**This document created by the Florida Department of Business and Professional Regulation -
850-487-1824**

TAC: Special Occupancy

Total Mods for **Special Occupancy** in **Pending Review** : 31

Diagram for elevator lobby barriers

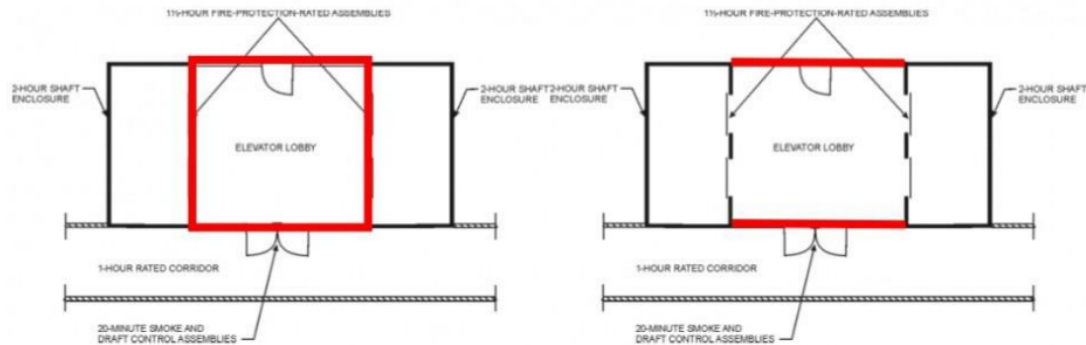
Reason: The intent of this proposal is to clarify lobby protection requirements – which walls are fire barriers, fire partitions or smoke barriers. This will also clarify what requirements are applicable for the elevator hoistway doors vs. the doors in the other walls of the lobby protection. The current language is inconsistent for the locations where elevator lobbies are specified. This protection of elevator lobbies is a combination of the elevator hoistway and exit stairway (direct access to a stairway is required for fire service an occupant evacuation elevator lobbies) shaft enclosure/fire barriers and the fire partitions or smoke barriers required for lobbies (405.4.3, 3006.3, 3007.6.2 and 3008.6.2) The intent of new 708.4.1 and revised 709.4.2 is to clarify that the fire partitions/smoke barrier criteria is not applicable to all the walls of the elevator lobby since the vertical shaft/fire barrier protections is adequate. Fires typically happen in the occupied portions of the buildings, not within the elevator shaft or the stairway. In addition, in situations where an elevator lobby is provided, the elevator shafts are double protected from smoke intrusion from a fire on the floor.

Diagram for which walls are fire partitions, smoke partitions or smoke barriers

Figure 403.1(1) Concrete and Masonry Foundation Details
(2020 Florida Residential Code)

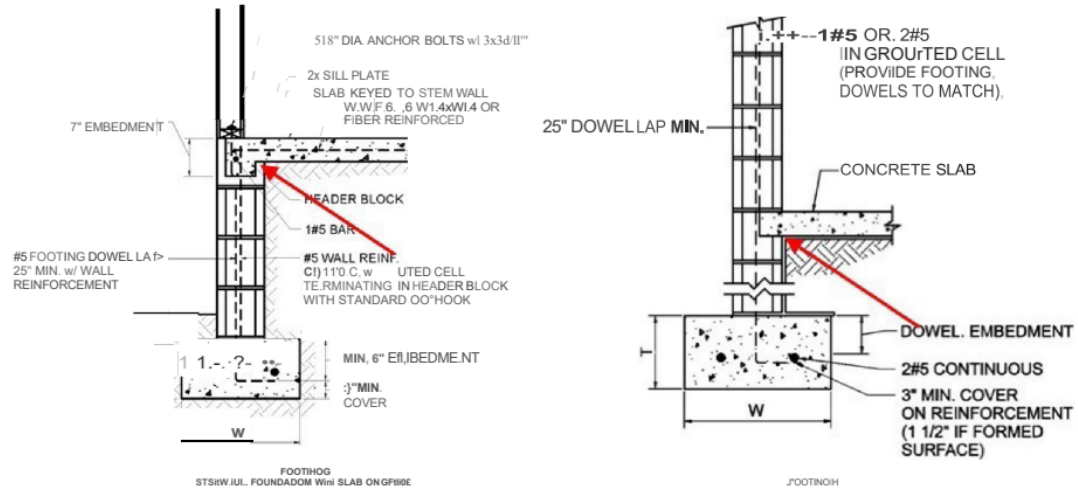
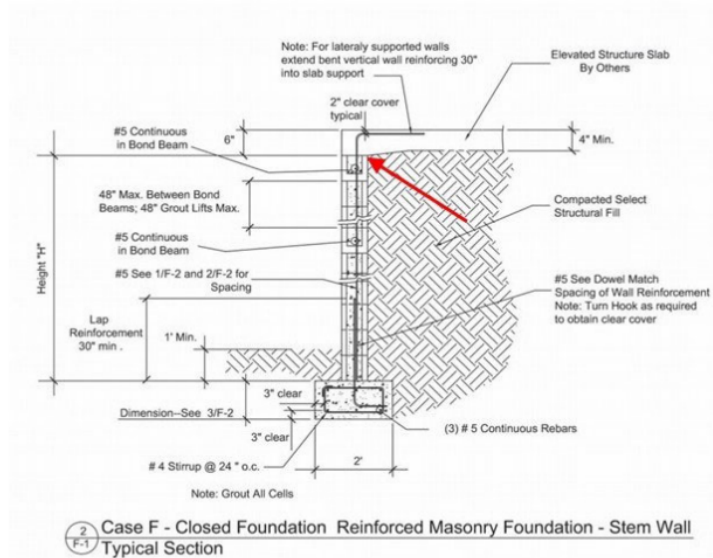
Reason: Section R322.3.3 Foundations, by exception, allows backfilled stem wall foundations in flood hazard areas designated as Coastal A Zones. Coastal A Zones are areas subject to waves that are between 3 feet and 1.5 feet high. Section R322.3.2 specifies elevation of the "bottom of the lowest horizontal structural members supporting the lowest floor." This proposal does not change the requirement. It clarifies where the "bottom of the lowest horizontal structural member" is located when applicants elect to use backfilled stem wall foundations so that designers, builders, and building officials can readily determine compliance. Relating the required elevation to the wall also removes any confusion should a slab have varying thicknesses at points interior to the perimeter walls. There are different ways to configure the foundation wall and slab connection. Three common options are shown in the figures, with arrows pointing to the top of the foundation wall, or top of the portion of the wall, supporting the slab.
